**DEPARTMENT OF VETERANS AFFAIRS  
NEBRASKA-WESTERN IOWA HEALTH CARE SYSTEM**

RE: Reply to a Notice of Unresolved Item.

The following is the response by the Department of Veterans Affairs Nebraska-Western Iowa Health Care System Alan J. Blotcky Reactor Facility to the NRC Unresolved Item 050-00131/09-04. License R-57, Docket # 50-131

Fig. 1 SOURCE HOLDER

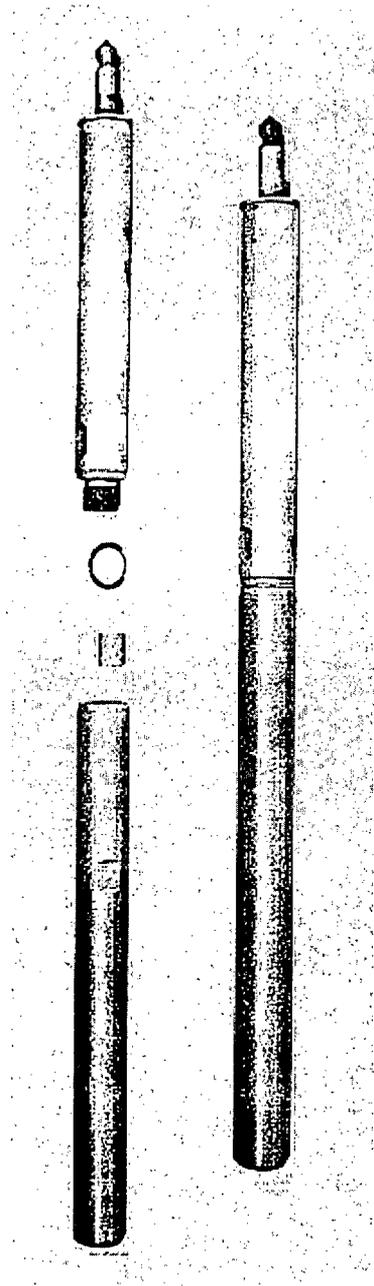
One unresolved item was identified during the inspection involving your possible possession of a polonium-beryllium sealed source. An unresolved item is a matter about which more information is required to determine whether the issue in question is an acceptable item, a deviation, a nonconformance, or a violation. You provided additional information about one polonium-beryllium sealed source in your possession. Based on half-life of polonium and the age of the source, we understand that the source has decayed to a negligible radioactivity level. Also, your staff conducted a records review and visually observed the components currently being stored in the reactor pool. Based on these reviews and observations, your staff believes that your facility does not possess any additional sealed sources.

In summary, the docket file records that we reviewed did not clearly provide an accounting of the sealed sources you had received, including which sources were transferred and disposed, and which sources

were still in your possession. Therefore, you are requested to provide the following information to the NRC before we can close Unresolved Item 050-00131/0901-04:

A listing of all sealed sources received, including receipt date, sources type, source holder, source activity, and serial number, if known.

A listing of all sealed sources transferred or disposed, including date of transfer and disposal and serial number, if known.

A listing of sealed sources(s) still in possession, by serial number if possible.

The following information is all that is currently known about the source holder for the sealed sources.

The neutron source holder (Fig 1) is the same general size and shape as a fuel element; thus, it can be placed in any vacant fuel or graphite element location. The upper and lower portions of the holder are screwed together to enclose a cavity that contains the source. A shoulder at the upper end of the neutron source holder supports the assembly on the upper plate.
